# Amendment Notice 1

**Licence Number** L7461/2000/8

**Premises** Leonora Wastewater Treatment Plant

**Date of Amendment** 24/07/2019

Figure 6: Spatial Reference

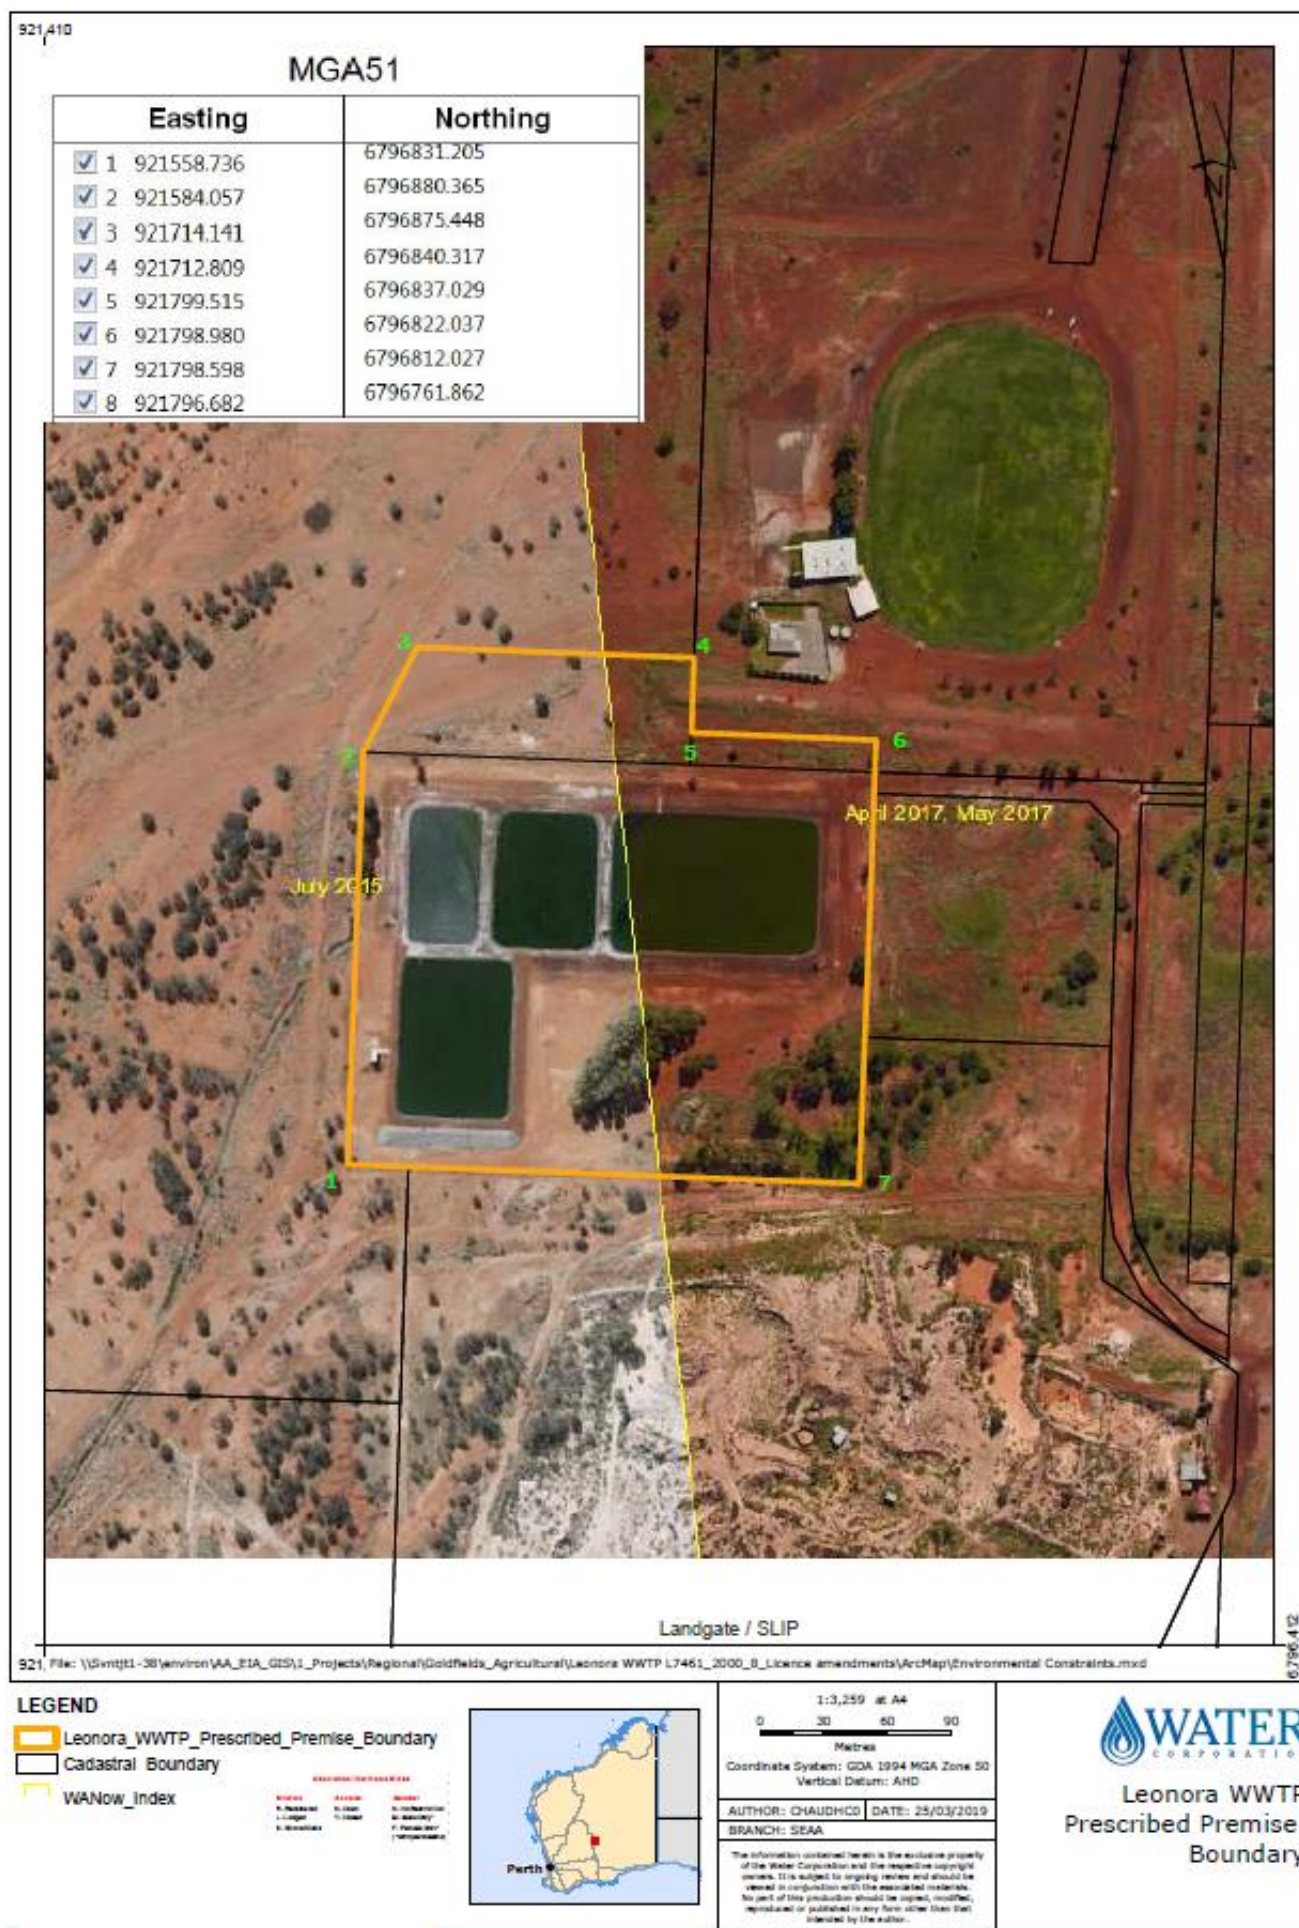
Conditions 4.1.1 and 4.1.2 of the Existing Licence includes Table 4.1.1: Improvement program. Improvement reference IR1 requires the Licence Holder to install and operate a Copper Doser to reduce algal loads. The Copper Doser has been operational for 3 years and was initially installed as a trial to attempt to reduce algae growth. Table 2 below summarises the performance of the Copper Doser. Following the recent upgrade to the WWTP, the Copper Doser is no longer required and its operation will cease. The Licence Holder will continue to record observational monitoring and suspended solids monitoring to determine the validity of the doser being offline. If algae levels rise above acceptable levels the copper doser will resume operation. IR2 required the Licence Holder to install permanent markers along the boundary of the Premises and provide the GPS co-ordinates of these markers. Figure 6 *Spatial reference*

below fulfils this requirement. Figures 1-5 below indicate the requirements of IR3, the installation of the earlier mentioned improvements have been complete. ASCONS and ESR drawings certifying the installed infrastructure were also submitted as supplementary information (*Final Leonora Supporting Info.pdf*) during the amendment application process.

# Premises layout showing emission and monitoring points

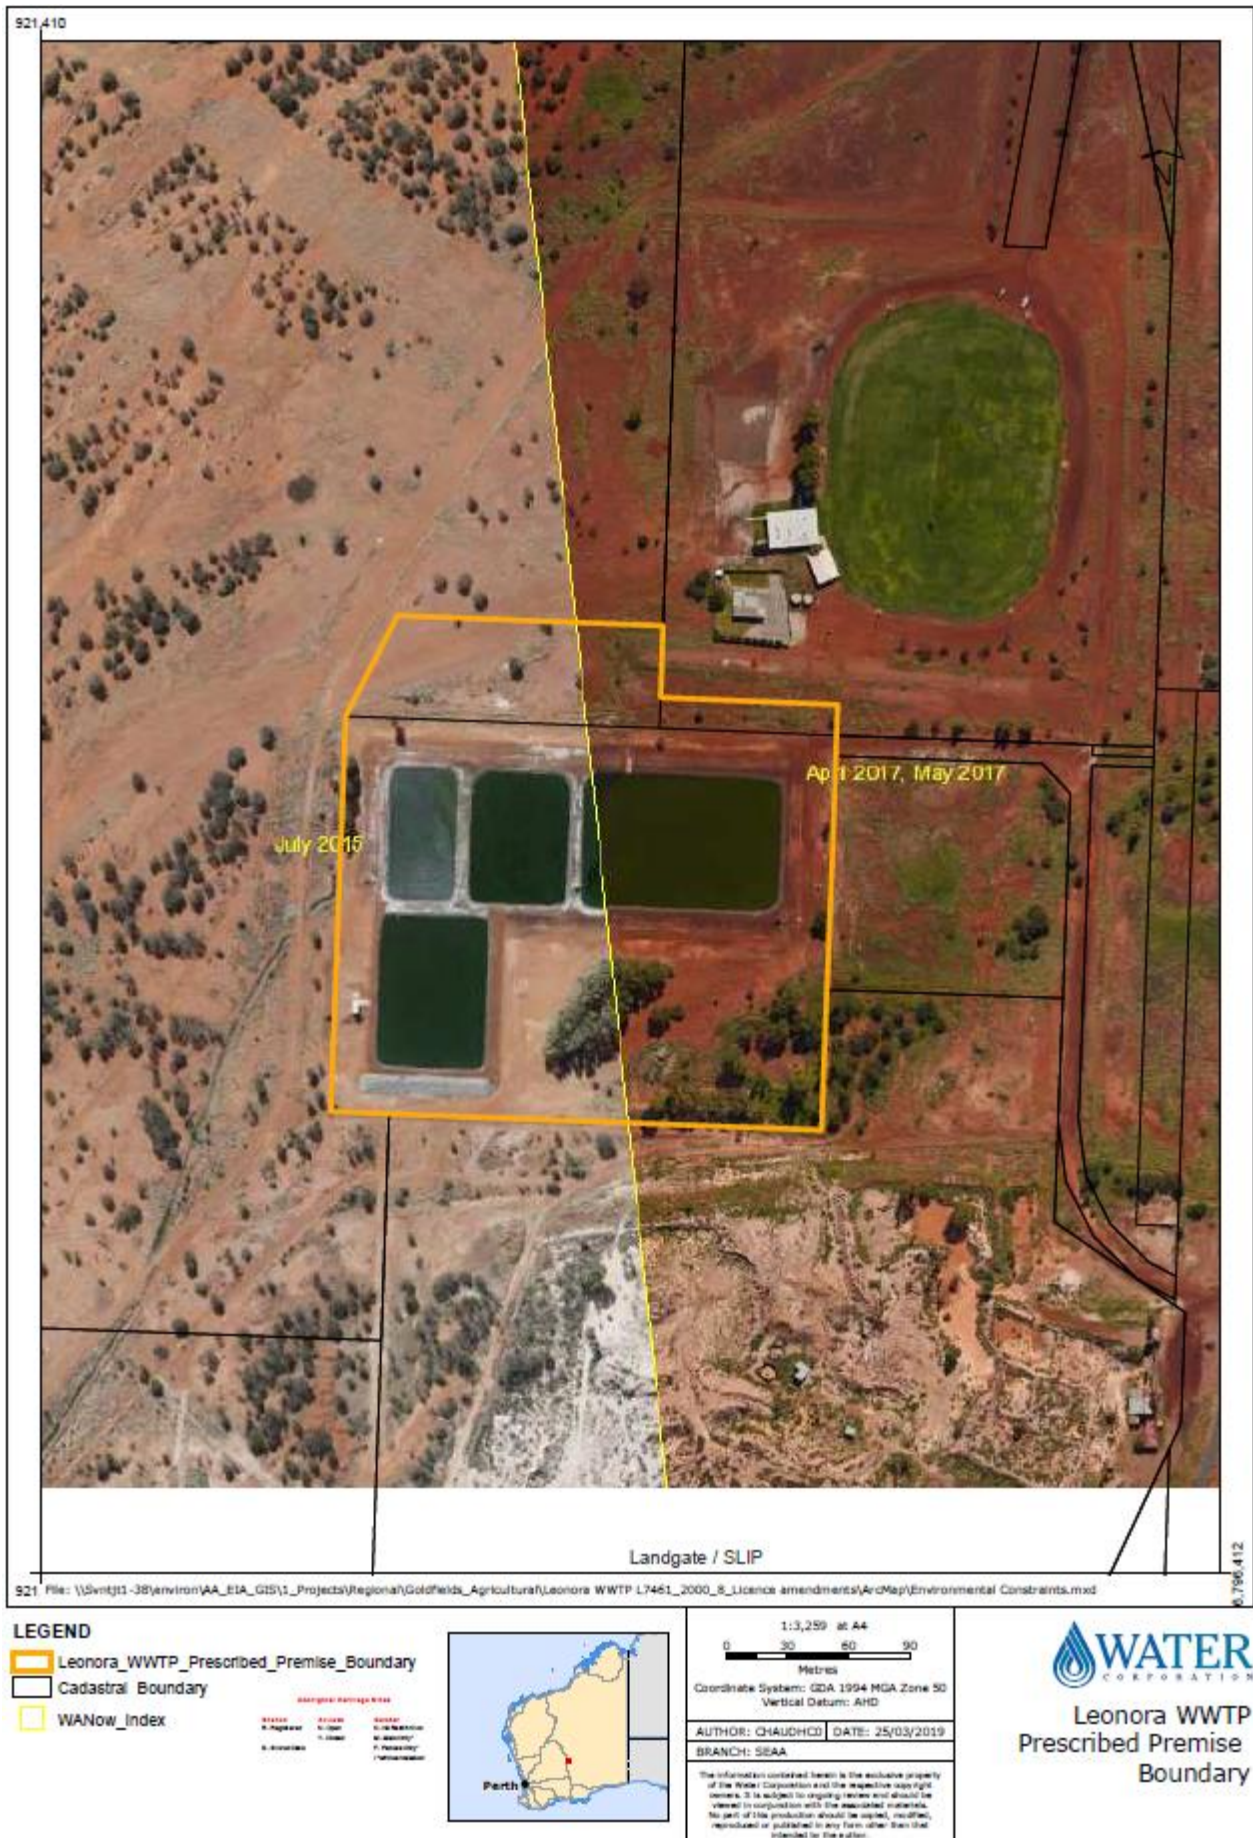
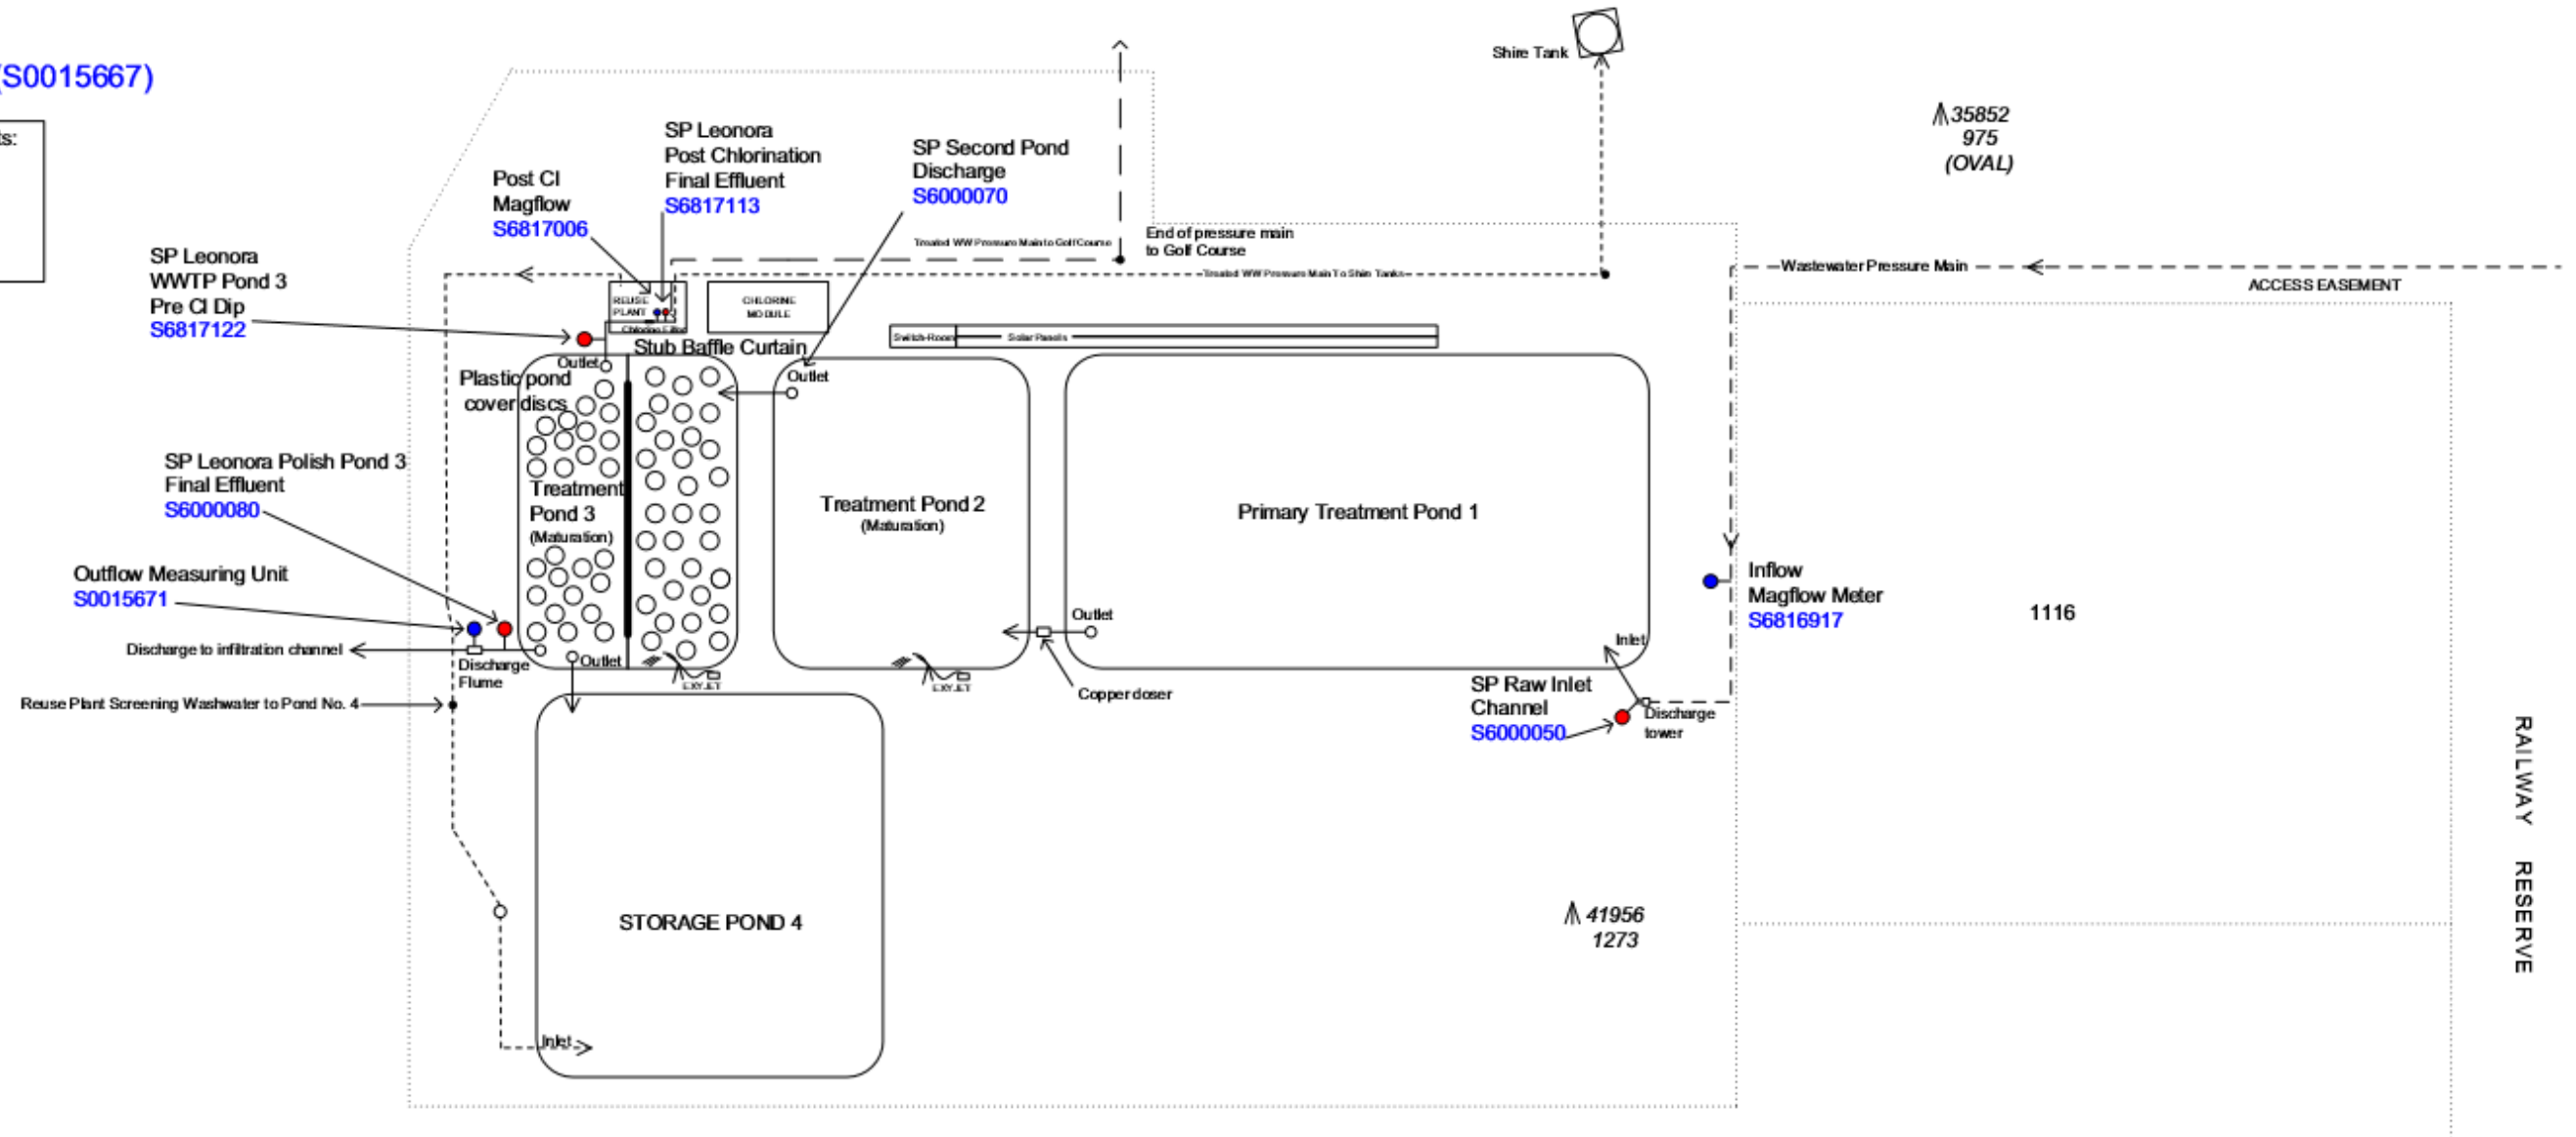
8. Schedule 1: Maps of the Existing Licence is amended with the removal of the *Premises Map* and the *Premises layout showing emission and monitoring points*; and the insertion of the maps below:
